Former Bauer Millet Site - Manchester

MMA PLANNING APPLICATION - LIST OF AMENDMENTS & MARKED UP DRAWINGS | 06 APRIL 2022

10053-MP-A-B5D9-MMA-003 | REV 01

Drawing Title: Building 3 - Ground Floor Plan

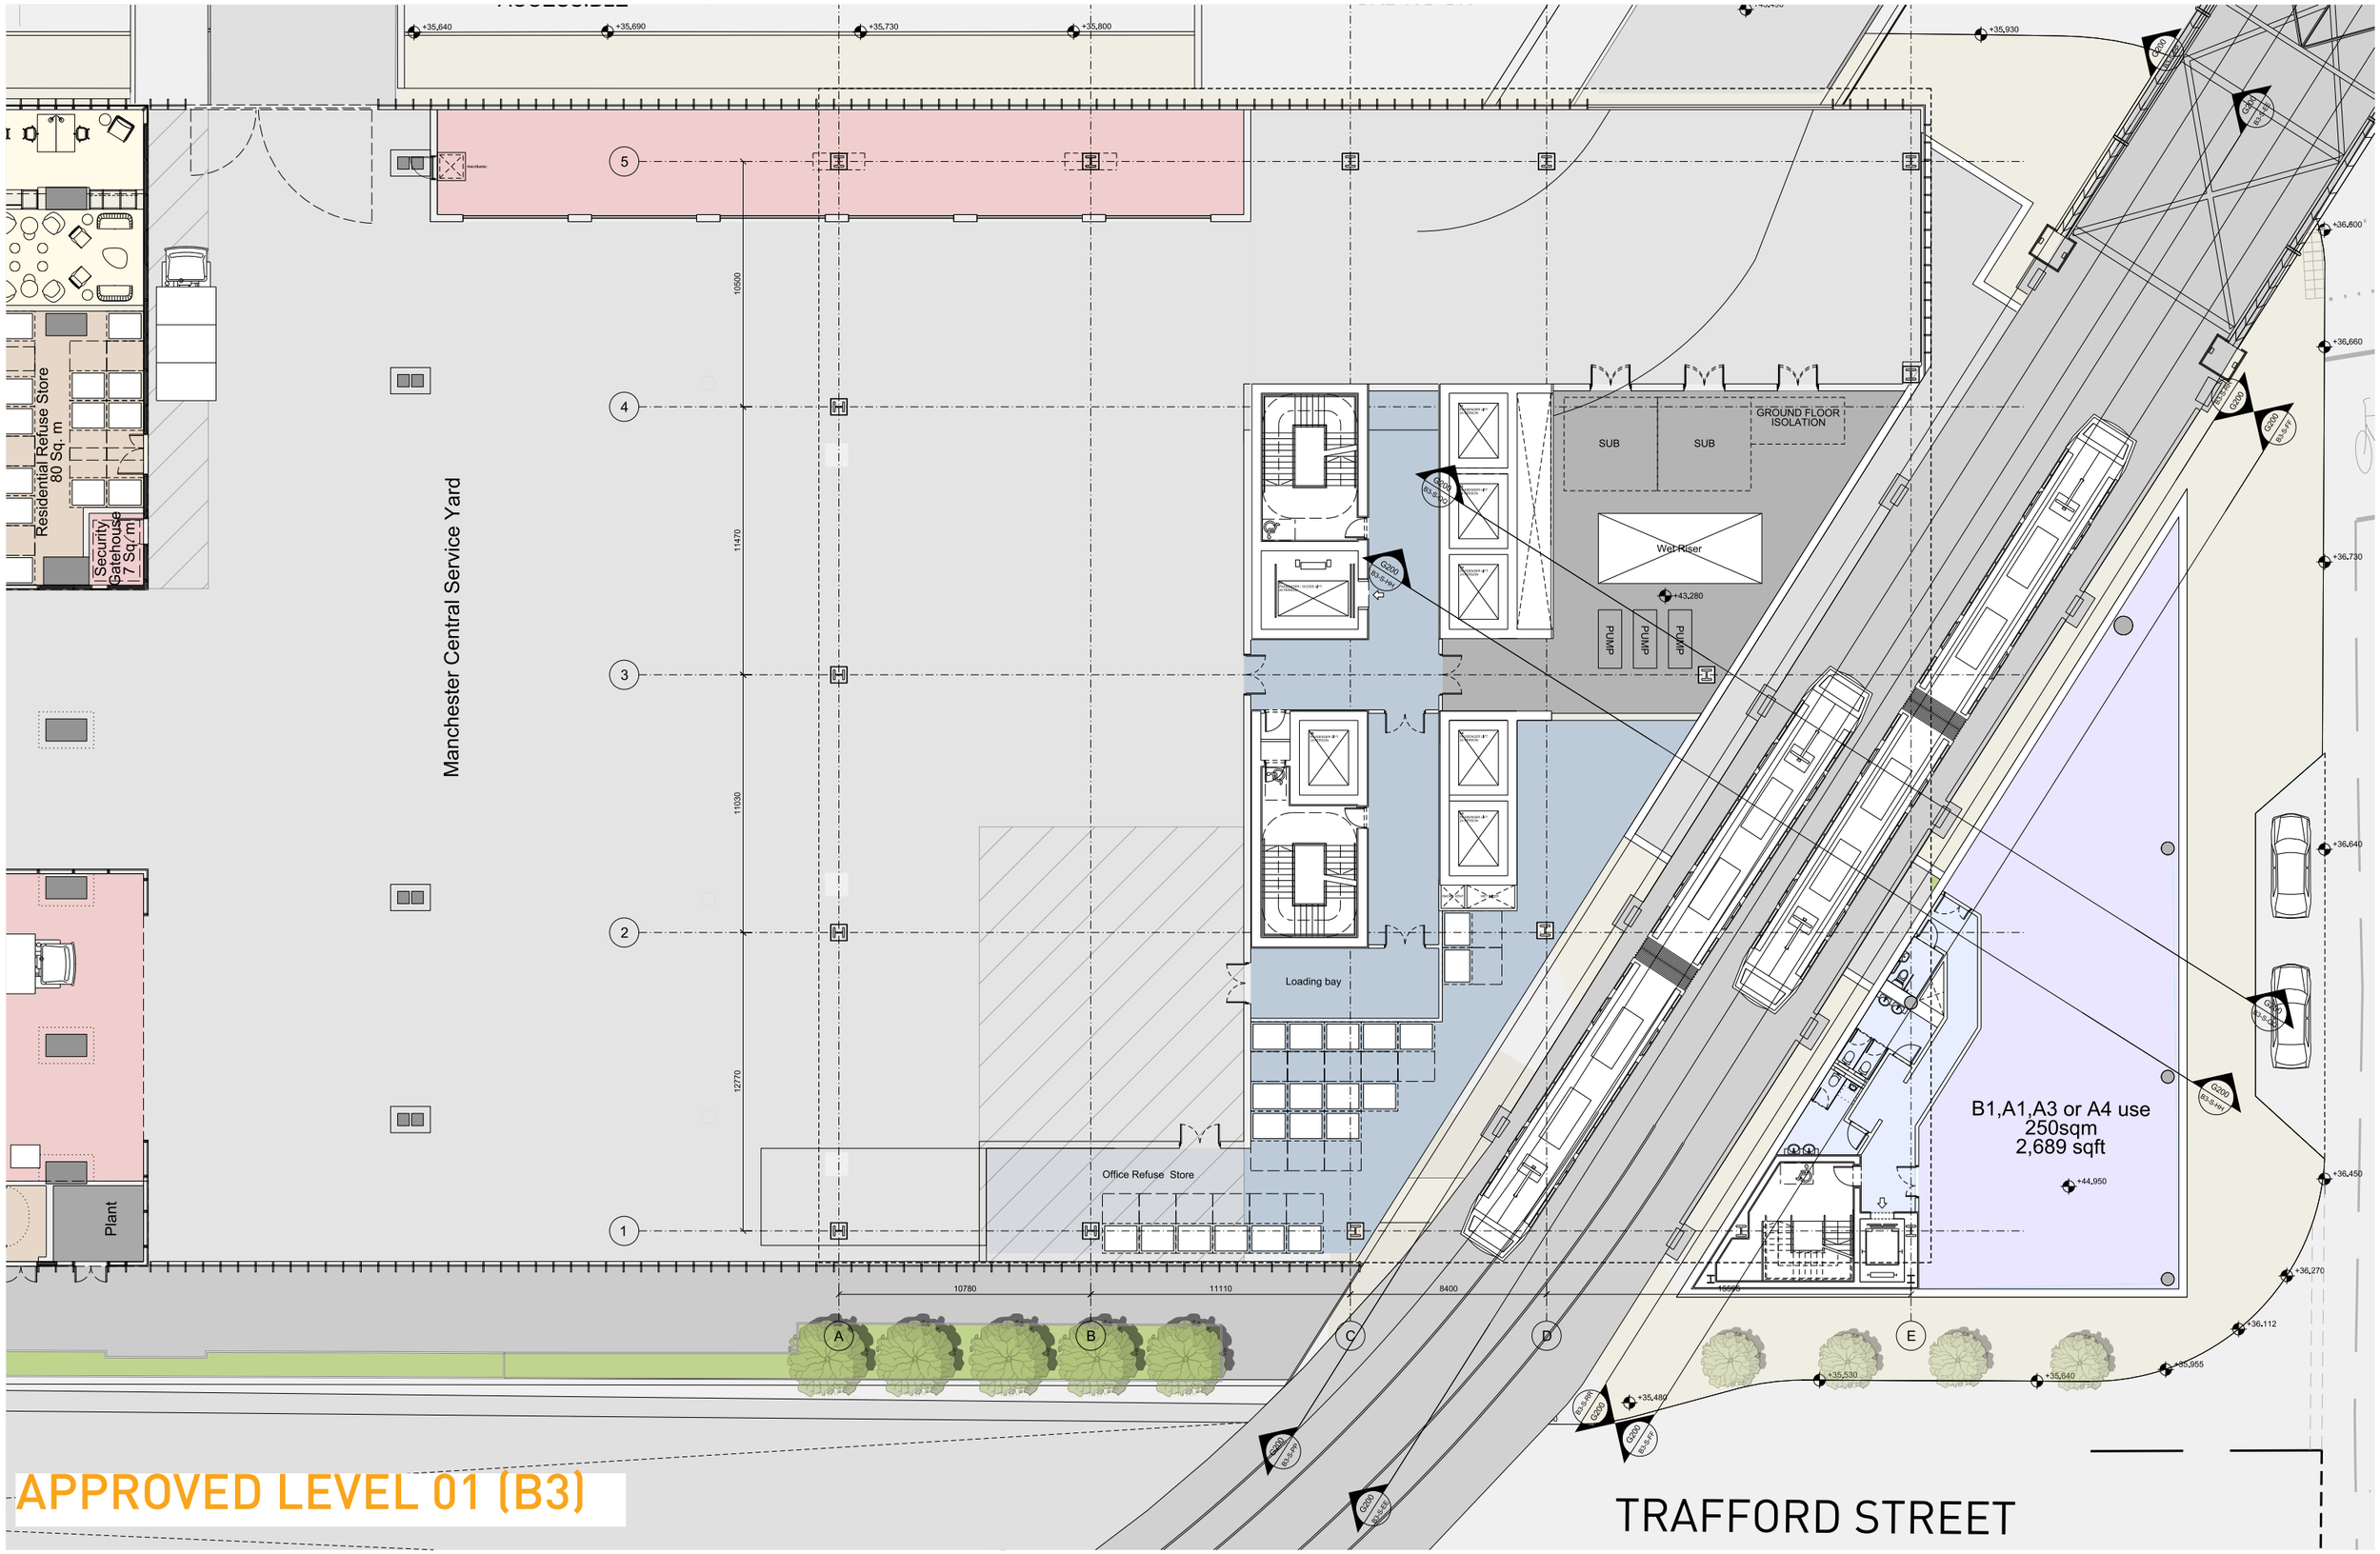
A - The office core has been rotated through 90 degrees and an additional passenger lift added to improve the performance / waiting times.

B - The office entrance has been moved further down Albion Street to remove internal level changes and increase the headroom available underneath the tram bridge.

D - The office cycle store, changing facilities, plant have been reconfigured to enable the cycles to be positioned within the historic arches and plant under the metrolink bridge.

PROPOSED TYPICAL LEVEL 001
LEVELS 05, 07, 09, 11, 13 (B3)

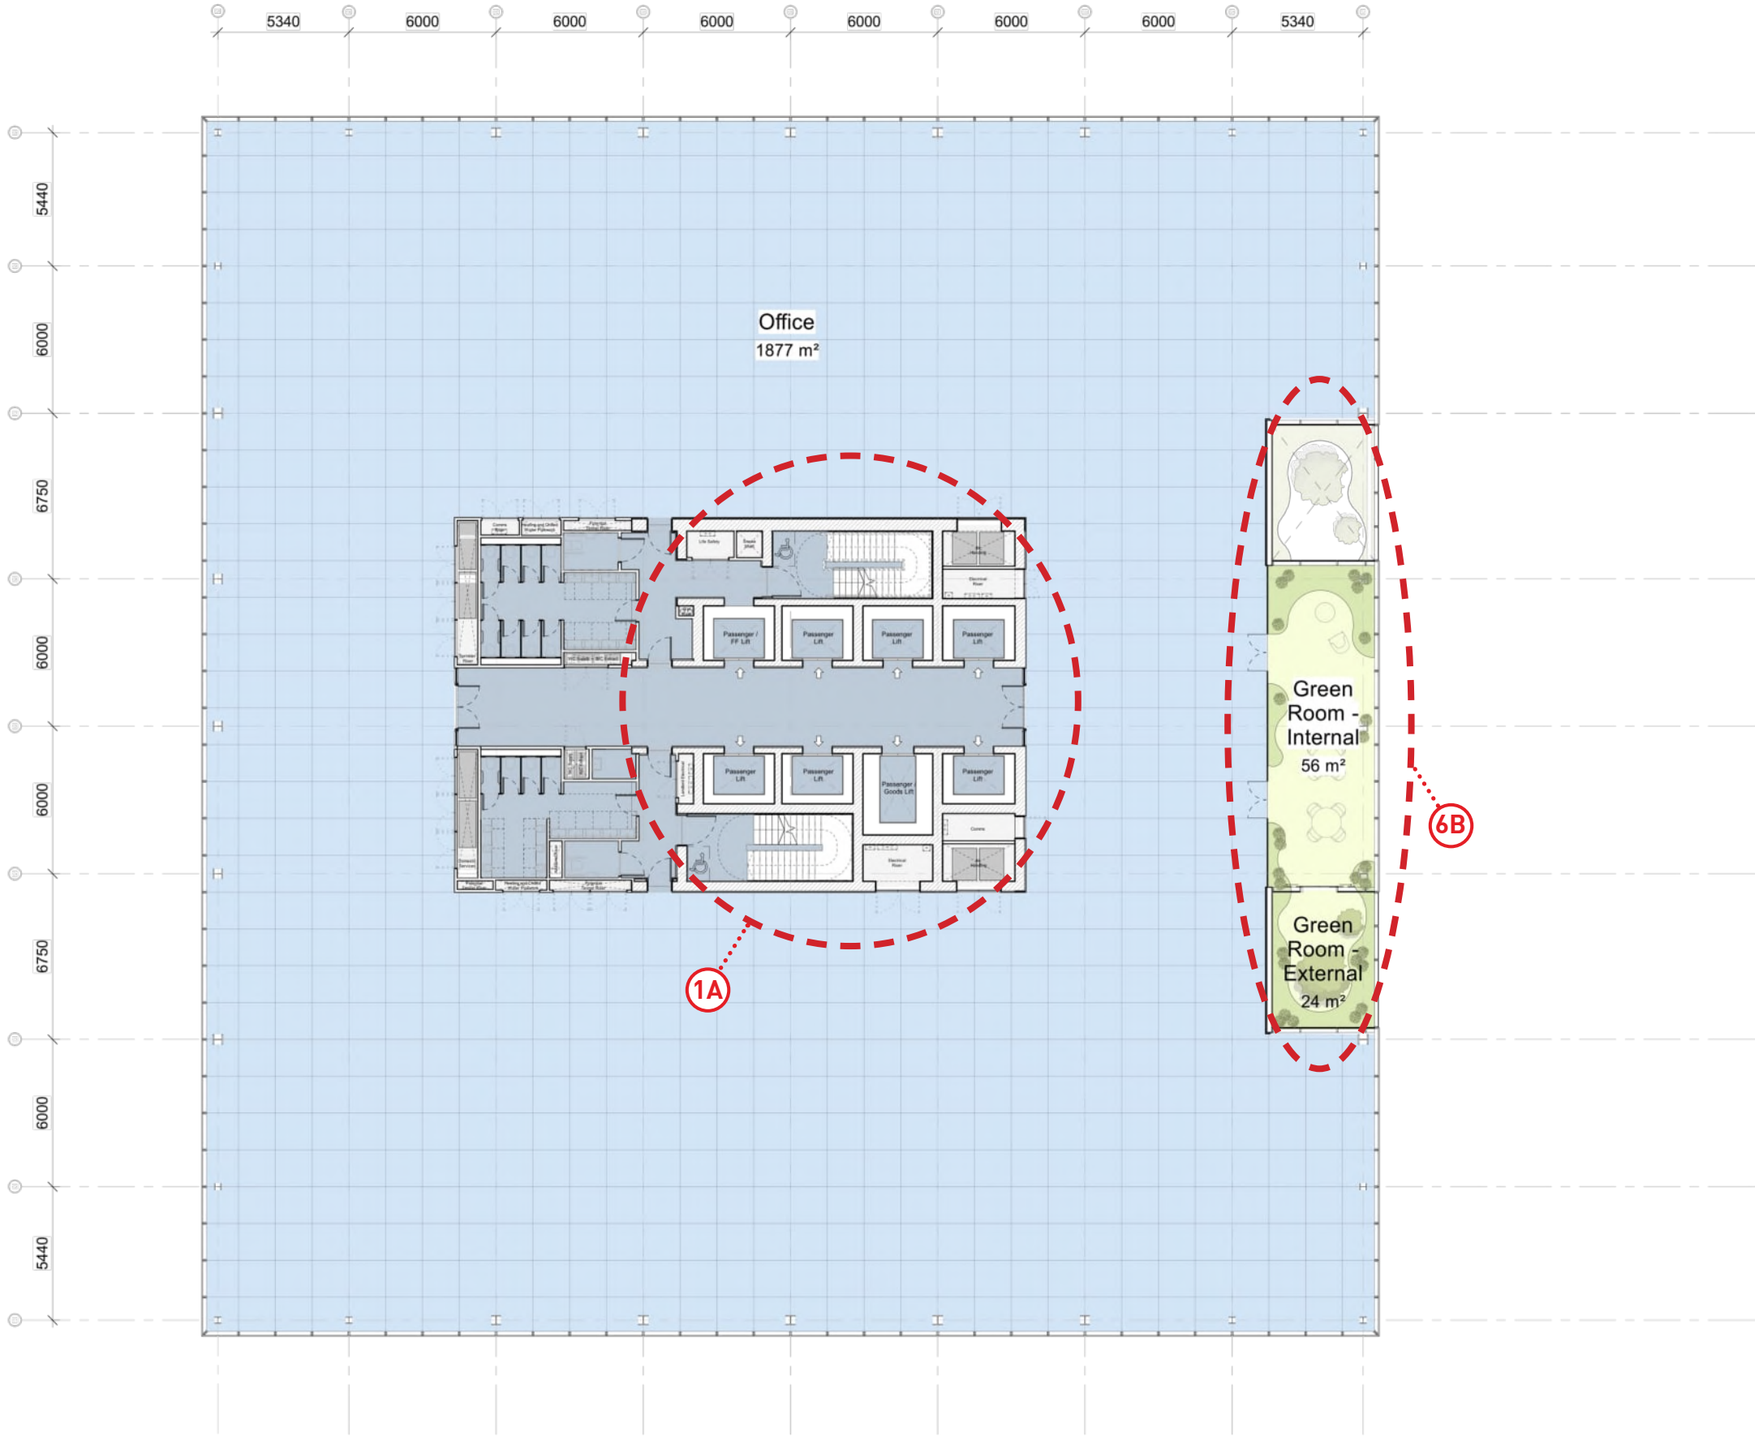
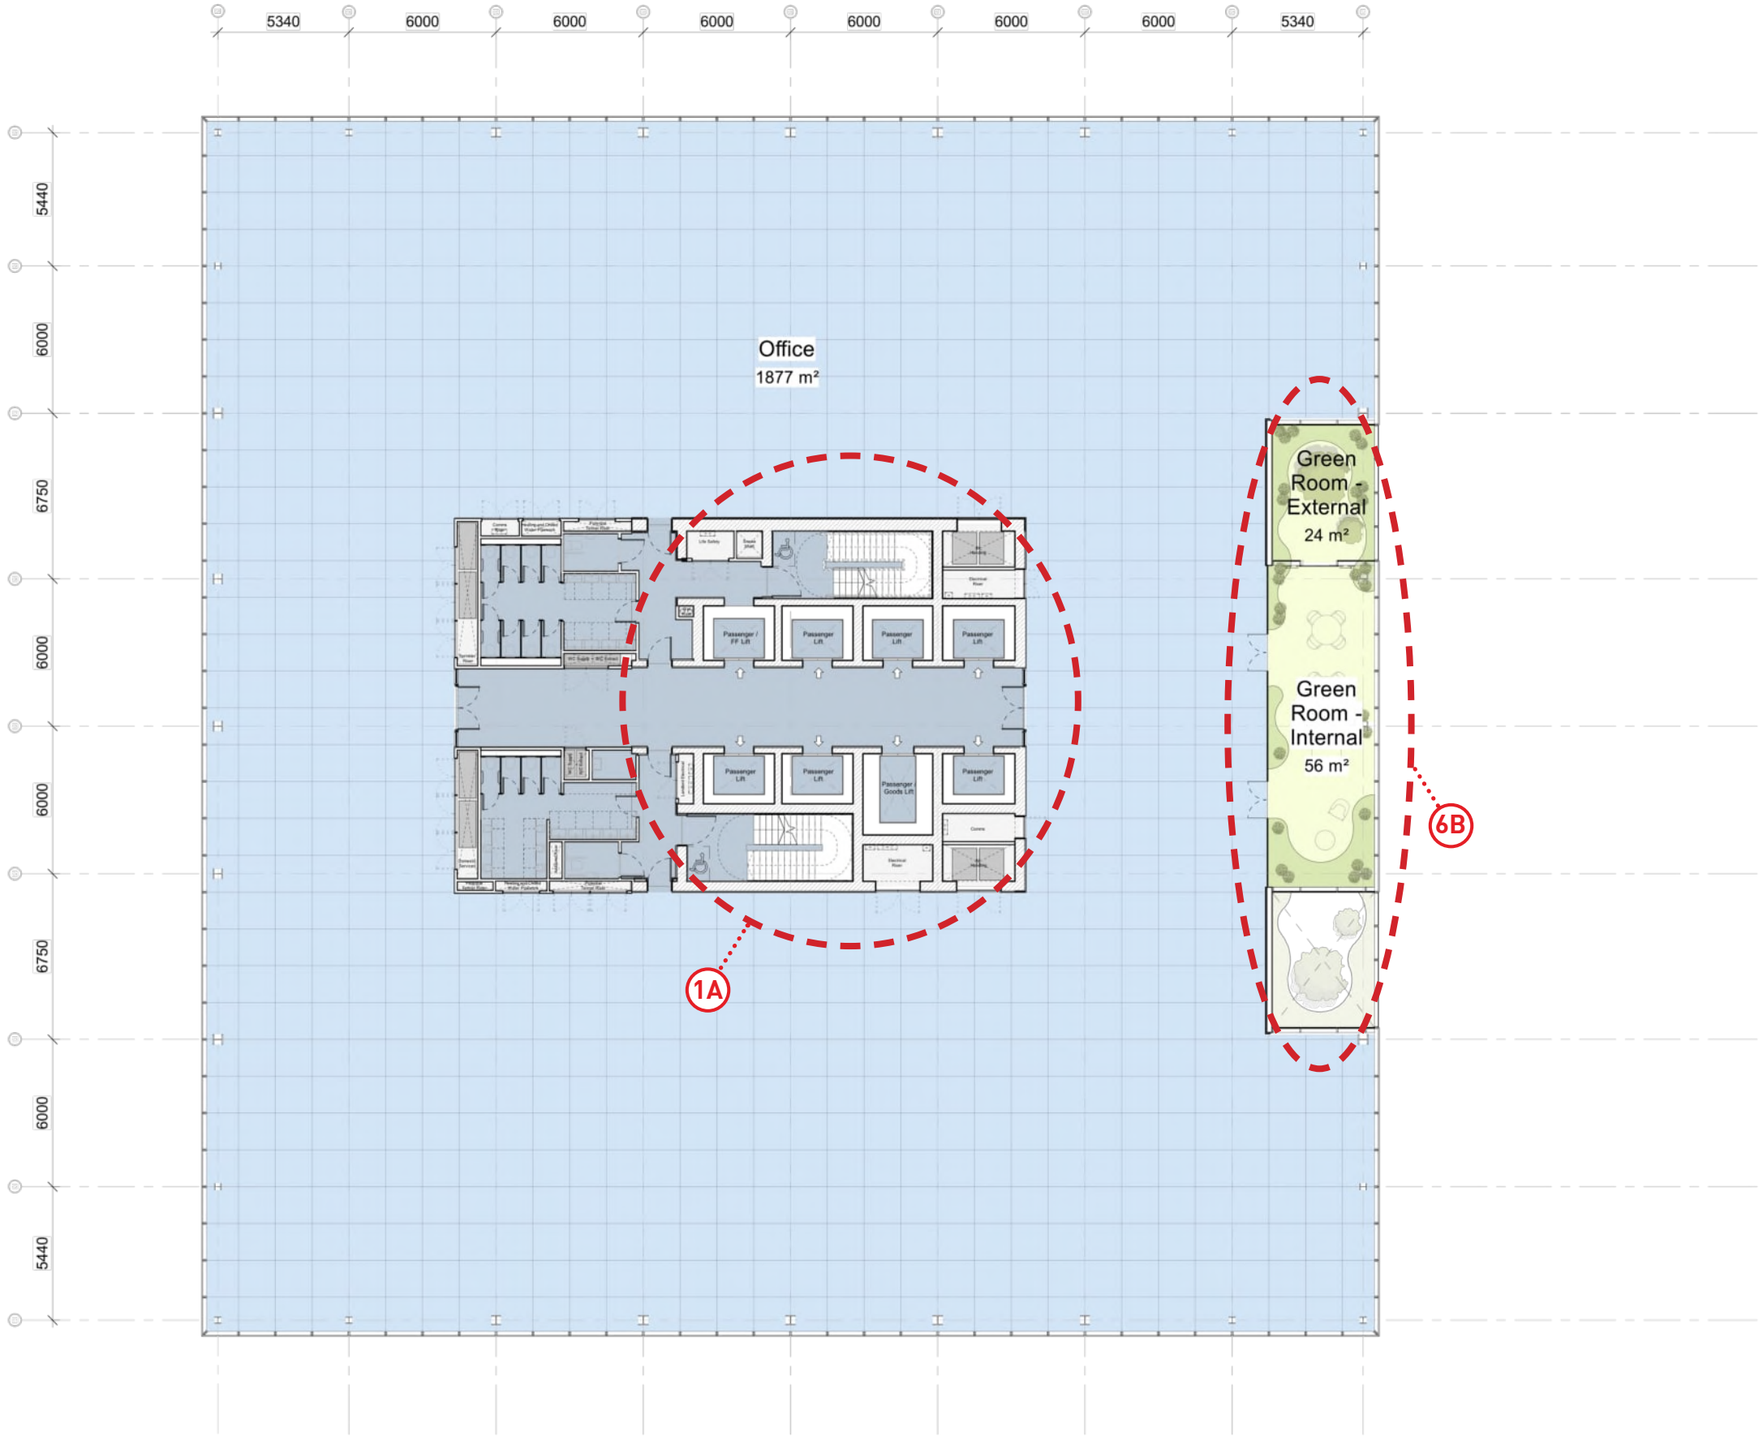
B - Amenity space for each office floorplate (level 03 upwards) has been added through the creation of landscaped green rooms which provide a focal point and visual interest to the floorplates.

C - The green rooms consist of double and single height spaces to allow for different scales of planting and provide a connection to nature through Biophilic design principles. The double height spaces have been designed as naturally ventilated wintergardens with a glass louvred façade. The position on the South East façade assists with solar control and provides uninterrupted views to the surrounding streetscape.
